ADDENDUM NUMBER 1

MARCIA COGGS HUMAN SERVICES CENTER
HVAC RENOVATIONS
Site #340, Bldg. #5600
1220 West Vliet Street
Milwaukee, WI

Project Number: P129-11608-02

Date of Addendum: November 23, 2011

SECTION "A" - DEMO

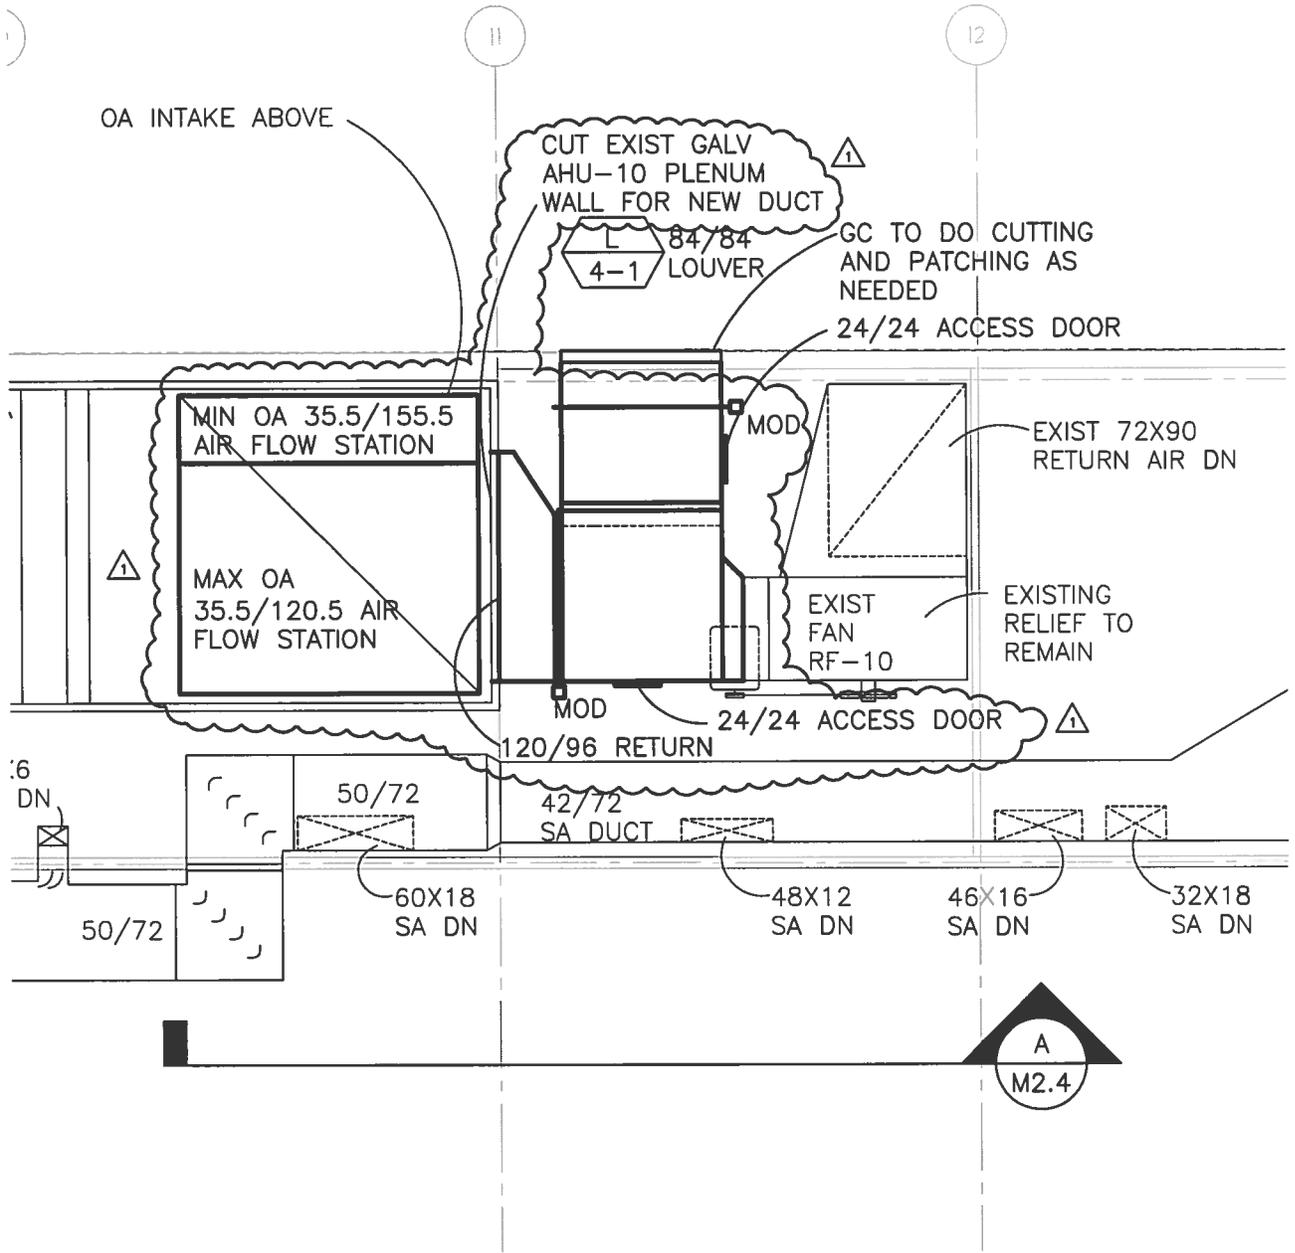
- a. Addendum drawing M1(attached) from drawing M1.4 SECTION "A" – DEMO.
 - i. Added existing air deflectors in mixed air plenum at existing AHU-10.
 - ii. Added existing fire protection piping and heads for demolition below existing relief air ductwork.

PENTHOUSE PLAN - NEW

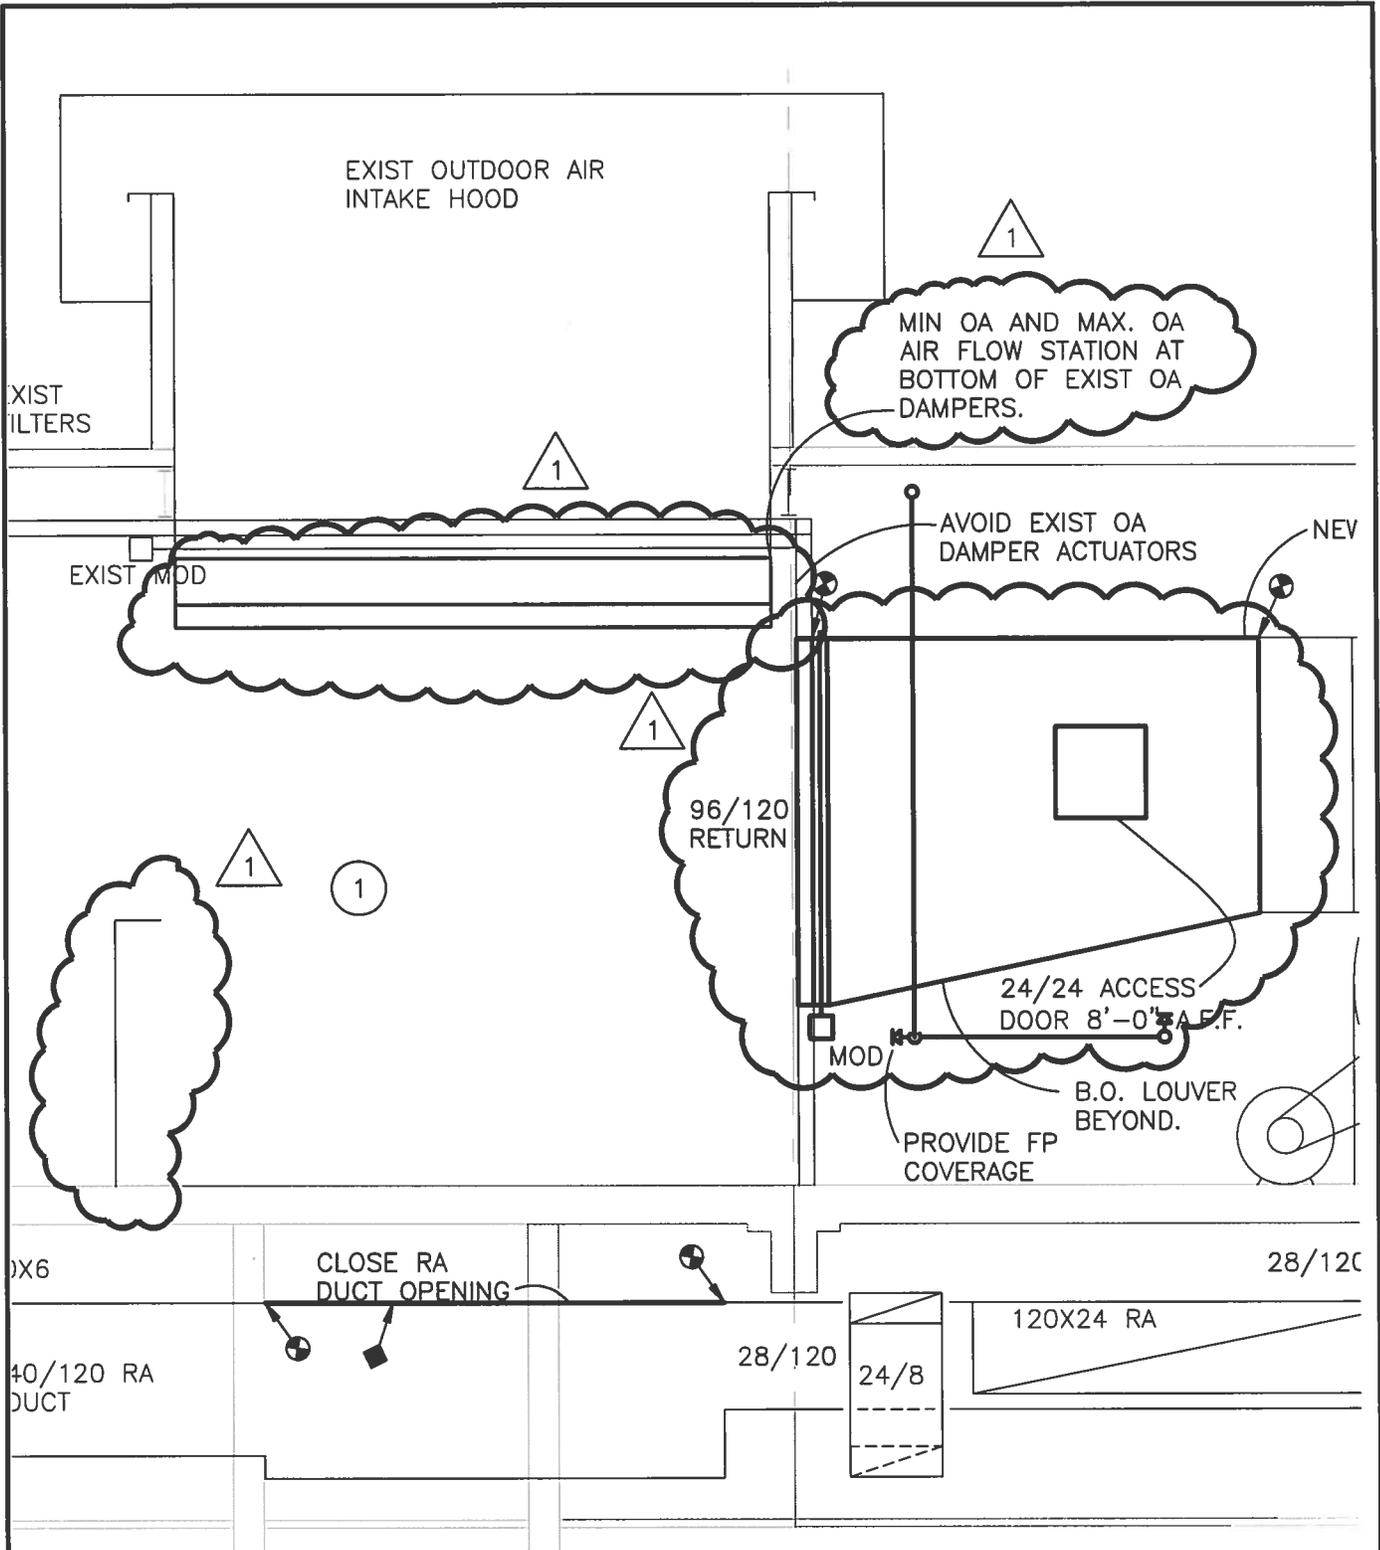
- b. Addendum drawing M2 (attached) from drawing M2.4 PENTHOUSE PLAN – NEW.
 - i. Revised ductwork from existing RF-10 outlet to existing AHU-10 mixed air plenum and ductwork to new relief louver.
 - ii. Added new air flow stations below existing control dampers for minimum outdoor air and maximum outdoor air.
